SITE PLAN

LEROY TWP., LAKE COUNTY, OHIO 357-0409

for: STEVE HAUSER (HAUSER REMODELING)
CLIENT OWNER

SUNSHINE ACRES SUBDIVISION / SUBDIVISION NAME; L-30 VOL. PG.	LOT / TRACT
P. 27 & 28 / SUBLOT NO.; PROCTOR RD. / STREET	VOLUME / PAGE
	PERM. PARCEL NO. / STREET

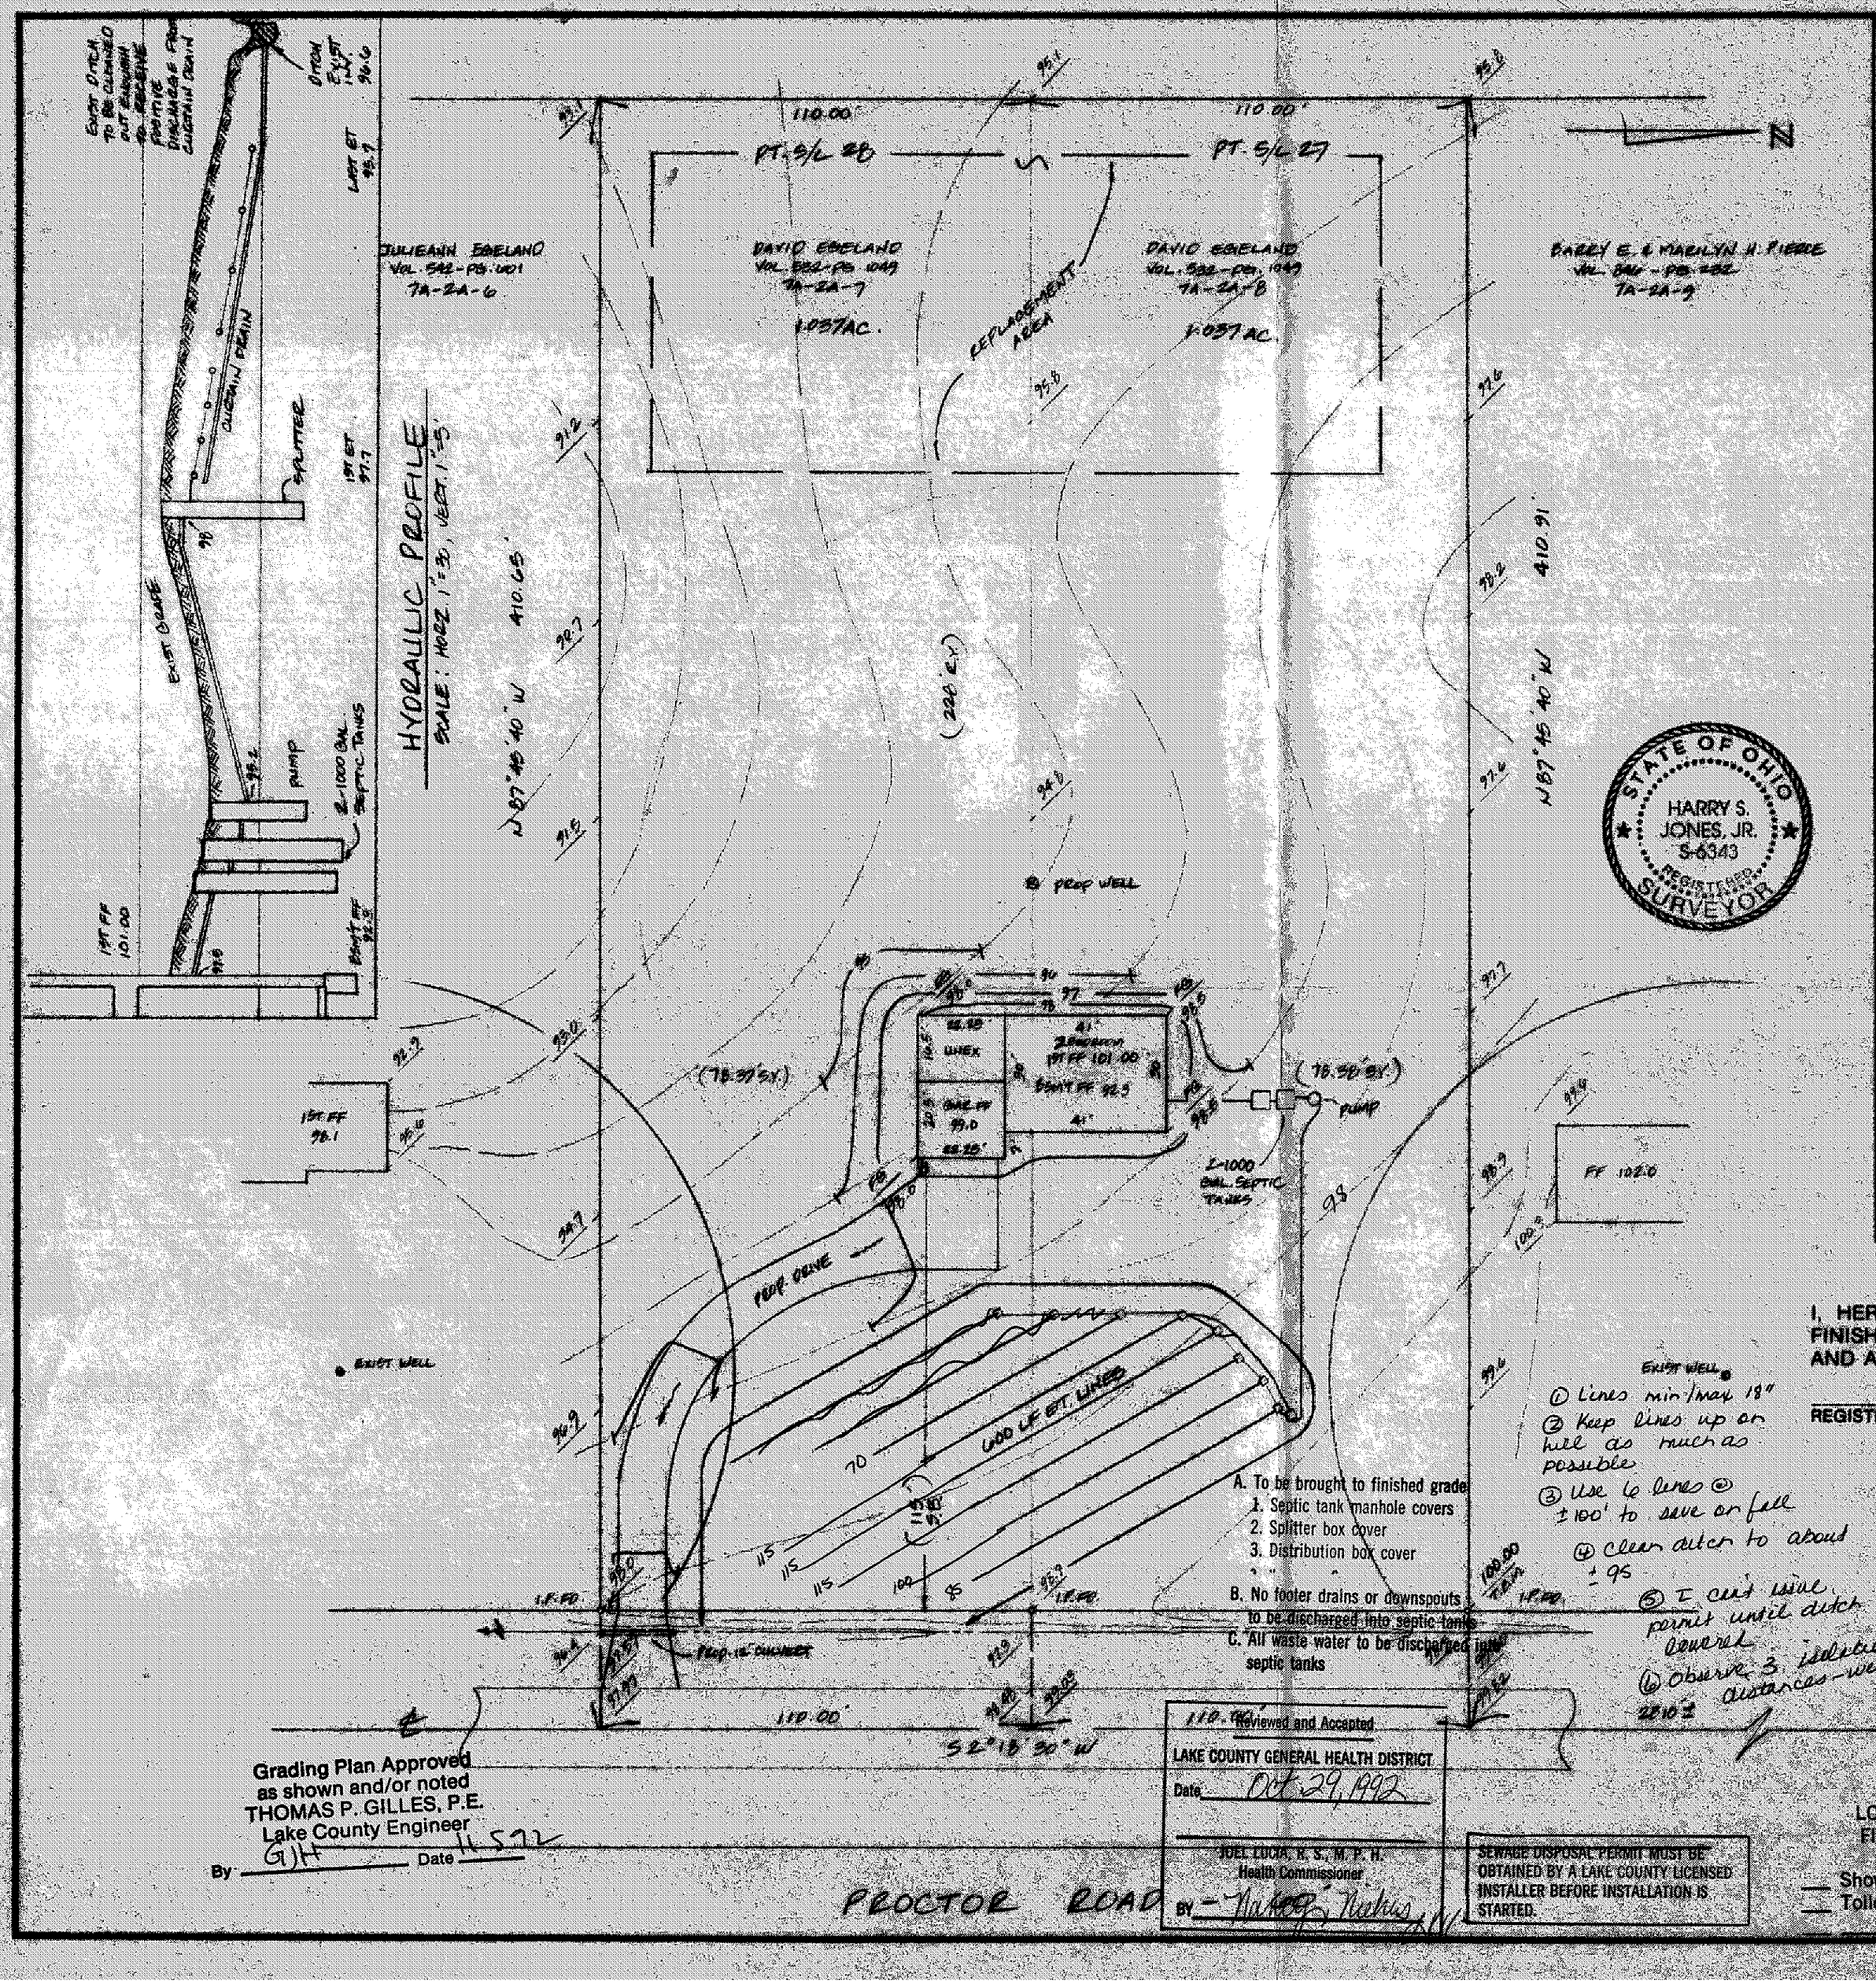
A. To be brought to finished grade
1. Septic tank manhole covers
2. Splitter box cover
3. Distribution box cover

B. No footer drains or downspouts to be discharged into septic tanks

C. All waste water to be discharged into septic tanks

① Lines min/max 18"
② Keep lines up on hill as much as possible
③ Use 6 lines @ ±100' to save on fill
④ Clean ditch to about ±95
⑤ I can't issue permit until ditch covered
⑥ Observe 3 isolation distances - wells
